Design Review Board Case #2019-0001

WMATA Building - Block 15 / 2395 Mill Road

Block 15 – DRB Work Session

Block 15 – Sketch of Ideas

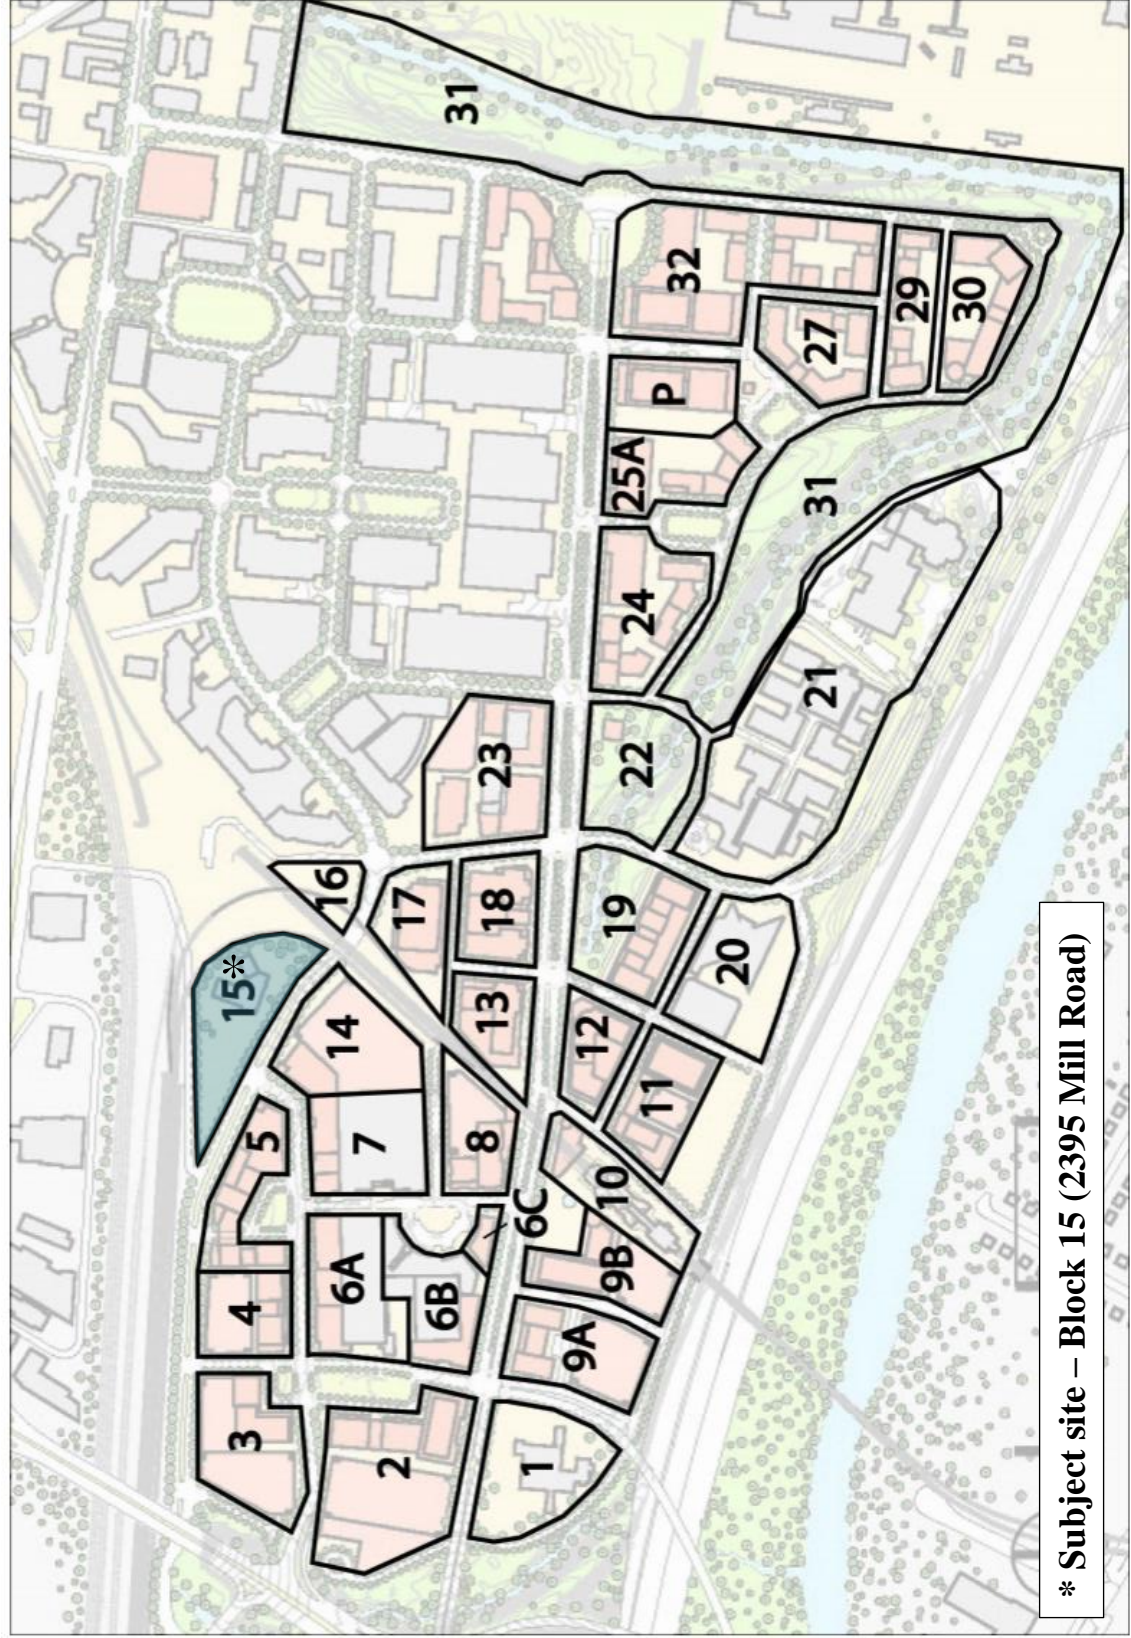
- 1. Elimination of 3rd (westernmost) curb cut.
- 2. Reduction in size of visitor lot, along with pavers and considerably increased landscaping.
- 3. Combination of lobby, visitor and main parking access at end of Mandeville Lane.
- 4. Suggestion to provide agreement for shared [service] access to future EE 15B site.
